# Access Compliance Report

## Public Rights-of-Way (Curb Ramps)

Intersection ID: 14567	Main Street: E_TREMONT_AV	Cross Street: LYNDHURST_AV	Location: S
ADA ID: 49516693EC99	Ramp Type: Directional1	Initial Pass/Fail: Fail	Overall Compliance: No
		Severity Score: 1.25

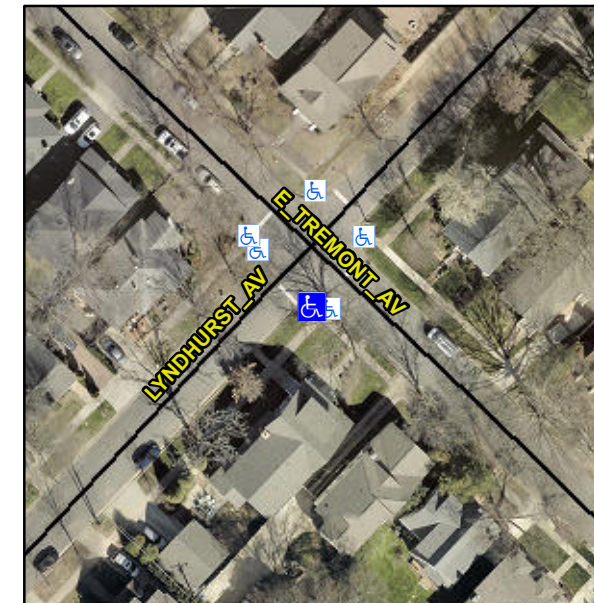
**R304.5.3**

Compliance	Description	Data	Compliance	Description	Data
N/A	Ramp Length (in)	44.0	N/A	Grade Break?	N/A
Yes	Ramp Width (in)	53.0	N/A	Grade Break Slope (%)	0.0
Yes	Ramp Slope (%)	6.1	N/A	Grade Break XSlope (%)	0.0
No	Ramp XSlope (%)	3.5			
N/A	Flare Type LT	N/A	N/A	Flare Type RT	N/A
N/A	Flare Slope LT (%)	N/A	N/A	Flare Slope RT (%)	0.0
N/A	Flare Traversable LT?	N/A	N/A	Flare Traversable RT?	N/A
N/A	Landing Length (in)	0.0	N/A	DWS Provided?	N/A
N/A	Landing Width (in)	0.0	N/A	DWS Contrast?	N/A
N/A	Landing Slope (%)	0.0	N/A	DWS Length (in)	N/A
N/A	Landing X Slope (%)	0.0	N/A	DWS Full Width?	N/A
N/A	Landing Curb? (Y/N)	N/A	N/A	DWS Offset LT (in)	N/A
N/A	Shared Landing?	N/A	N/A	DWS Offset RT (in)	N/A
N/A	Gutter Ponding?	0.0	N/A	Gutter Slope (%)	N/A
N/A	Gutter Lip Ht (in)	0.0	N/A	Gutter X Slope (%)	N/A
N/A	Painted X Walk1?	No		Road Slope (%)	5.2
	X Walk 1 Direction	To NW		Road X Slope (%)	2.8
	X Walk 1 Width (in)	N/A		Clear Space?	N/A

X Walk 1 Slope (%)	5.2	N/A	Clear Space to XWalk (in)	N/A
	X Walk 1 X Slope (%)	2.8	N/A	Storm Grate/Utility Hazard?	N/A
N/A	Ramp inside XWalk1?	N/A		Storm Grate/Utility Type	
N/A	Any Obstructions?	N/A			N/A
	Obstruction Type		Yes	Surface Condition? (G/P)	Good
			N/A	Curb Slope (%)	36.6

**Remove & Replace Entire Ramp.**
